93 Swain's Lane

2023/3475/P - 93 Swain's Lane

Delegated Report (Members Briefing)		Analysis sheet N/A / attached		Expiry Date: 18/10/2023	
				Consultation Expiry Date: 08/10/2023	
Officer			Application Number(s)		
Daren Zuk			2023/3475/P		
Application Address			Drawing Numbers		
93 Swain's Lane London N6 6PJ			See draft decision notice		
PO 3/4	Area Team Signature	C&UD	Authorised Officer Signature		
Proposal(s)					
Single storey rear extension at lower ground floor level (excavation into hillside); upper ground floor rear extension (above ground); new rooflights on proposed single storey rear extension; new projecting rooflight on main roof; replacement of existing garage doors with glazing.					
Recommendation(s):		Grant householder planning permission			
Application Type:		Householder Planning Permission			
Conditions or Reasons for Refusal:		Refer to Draft Decision Notice			
Informatives:					
Consultations					
Adjoining Occupiers:	No. notified	00	No. of responses	01	No. of objections

Fig 2. Proposed front elevation

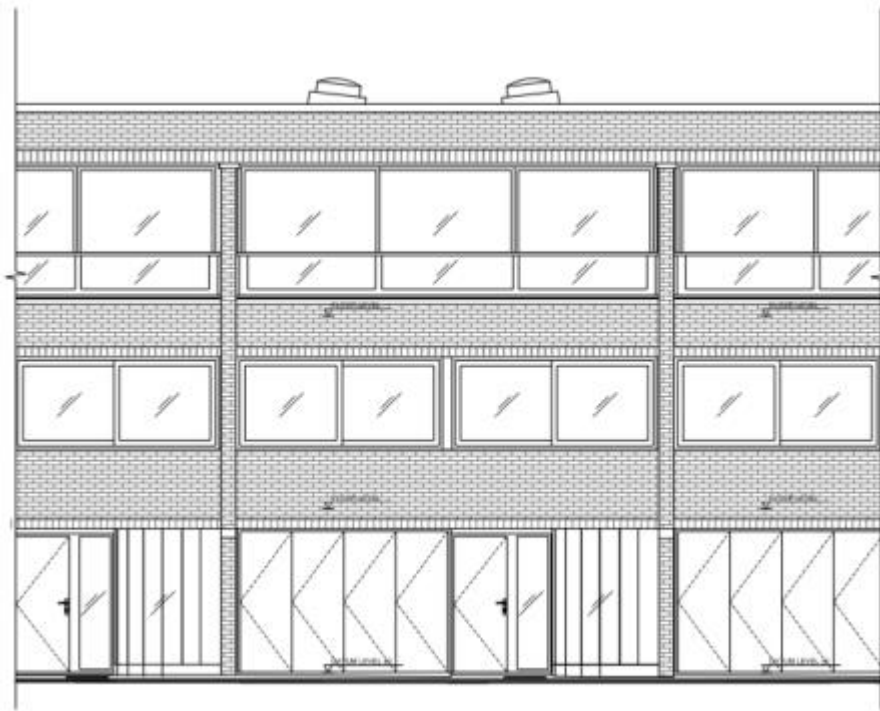
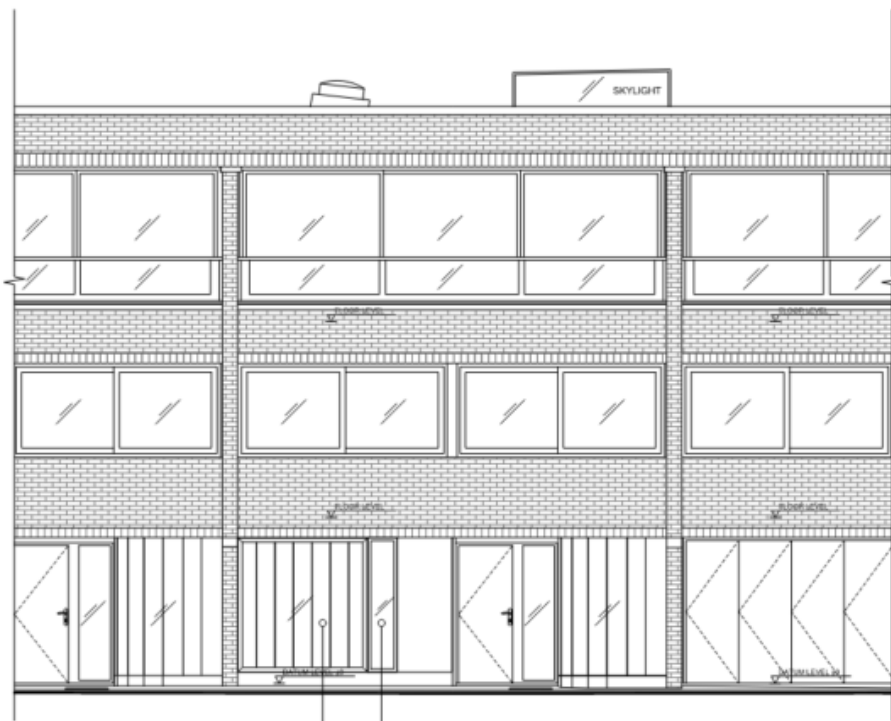
<p>designed by Haxworth and Kasabov. That continuous character uniting the whole terrace, also manifests on the ground floor with a repeating pattern of entrance, curved glass, brick pillar and block colour.</p> <p>The proposal appears to replace a block of colour with glass, which would totally destroy the continuity of the terrace. The front elevation of the whole terrace must be maintained as it is. This is an important 20th century development, one of many in Highgate in Camden and Haringey. The curved internal lobby to the left, references the external curved glass to the right of the entrance and should be retained.</p> <p>There is no assessment of the impact of a basement, on the hydrology of the area. We would like to see a greater use of SUDS, an assessment of the environmental impact including a plan to maintain or increase biodiversity in the rear garden, and a plan to minimise energy use and approach neutral carbon.</p> <p><i>Officer's Response:</i></p> <ul style="list-style-type: none"> <i>The proposed works along the ground floor front elevation are identical to those approved under ref. 2021/4768/P (dated 10/11/2021). The works are considered to be a sensitive alteration to the unique design of the group of terraces and are thus acceptable on design grounds.</i> <i>A basement impact assessment (BIA) has been reviewed and confirmed acceptable by a third-party auditor (Campbell Reith).</i> <i>Given the small scale of the rear extension, the inclusion of SUDS measures are not considered necessary in this instance.</i>

- 3.4. The installation of rooflights on the proposed rear extension and to the main roof are considered acceptable in form and scale and will not impact the character of the host building or wider terrace.
- 3.5. Works to the ground floor front elevation, which include replacement of the existing garage doors with Pilkington Profilit glazing to match existing, are identical to those approved under ref. 2021/4768/P dated 10/11/2021. As with the previous application the loss of the garage doors and their replacement with glazing is considered to be acceptable on the basis that the change would not affect the form and shape of the ground floor and would not affect the sense of rhythm along the wider terrace.

Fig 6. Proposed rear elevation

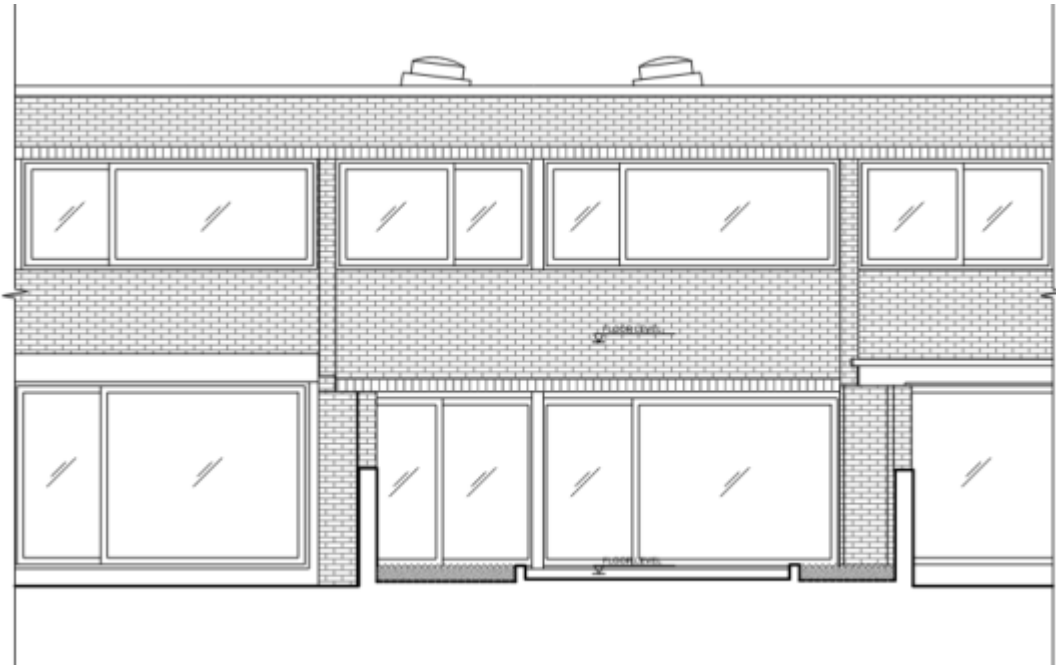
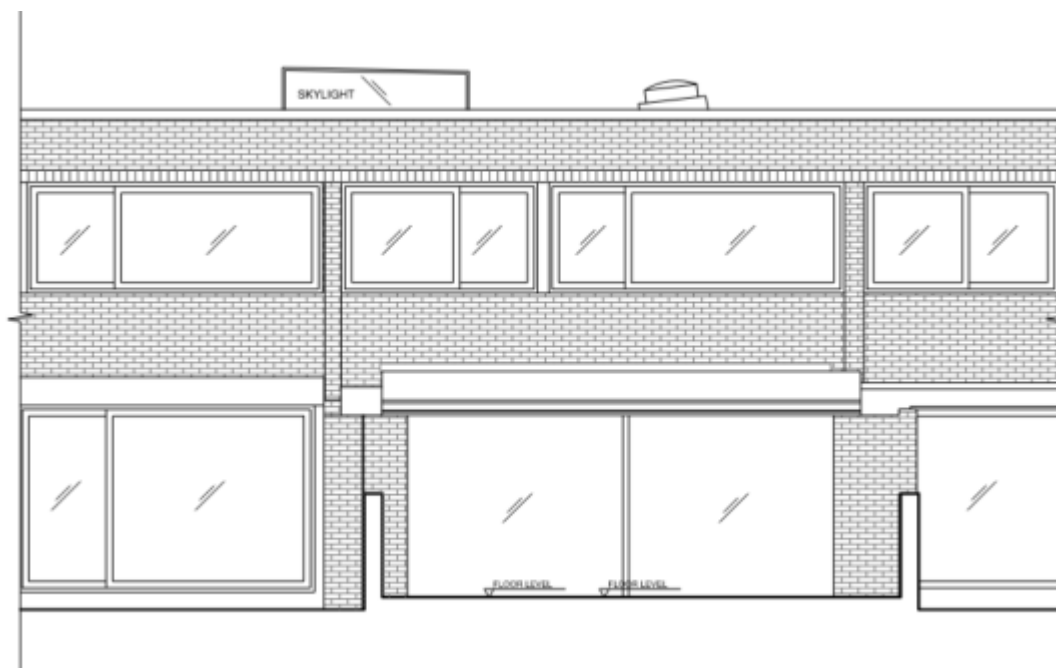
- The new ground floor extension extends beyond the two adjoining approved extensions. Any proposals should be examined in conjunction with adjoining properties to ensure the protection of the architectural integrity of the block. Any new rear extension should respect the emerging building line and should not extend beyond this either in depth or height.

The design of the rear extension is discussed in Section 3 (Design and Conservation).

Fig 9. Proposed section

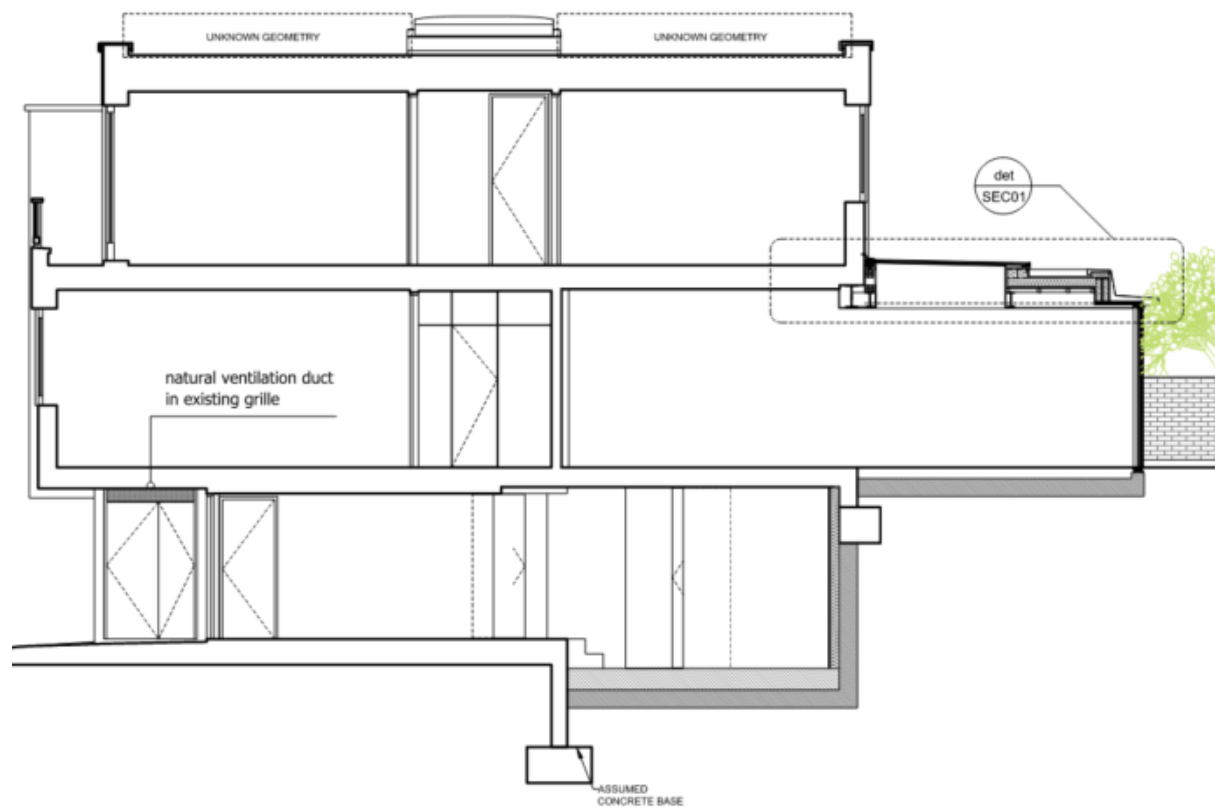
- The proposal also looks at effectively forming a new the basement to the rear by extending the access level to the rear. There are a couple of issues with this. The first is that by doing so, the basement wall will extend beyond those of the adjoining properties and, as such, result in ground water being diverted to the neighbouring properties where they will remain potentially constrained. This is a steep hillside leading down to the historic Highgate Cemetery. Highgate is notorious for hydrology problems and the investigations to date do seem to have only been carried out in a period of extended dry weather. Secondly, the extended access level will form a full basement to the rear without access to light or air and will require ventilating and thus plant, as mentioned in no 3 above.

A basement impact assessment (BIA) has been submitted, reviewed, and confirmed acceptable by a third-party auditor (Campbell Reith). The BIA included an assessment of the area's hydrology, which was not raised as a concern. The application does not propose any new plant facilities. If any plant facilities were to be proposed in the future, a planning application would be required and subsequently assessed against Council policy and guidance.

Fig 1. Proposed ground floor plan, with rear garden

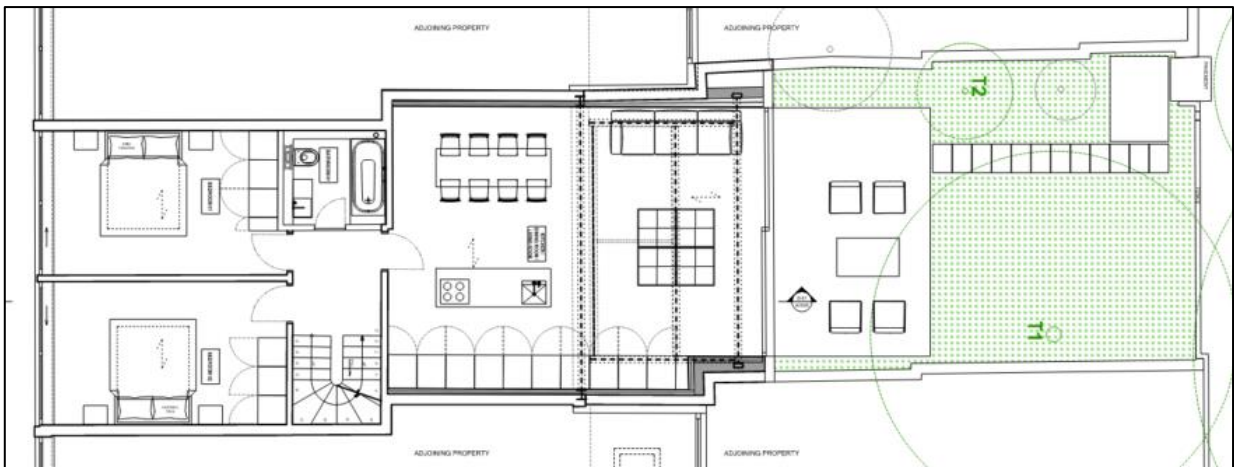
- 3.3. The proposed ground floor rear extension, although deeper than neighbouring rear extensions, is considered subordinate and respecting of the prevailing pattern of development of the terrace. Sufficient rear garden space will be retained, thus protecting the amenity of current and future occupiers (see Fig 1 below). The use of brick to match the existing terrace is welcomed and given its low siting and location to the rear, the use of aluminium is considered acceptable and help differential it as a modern addition. Full height fenestration is a characteristic of the terrace and thus considered acceptable.
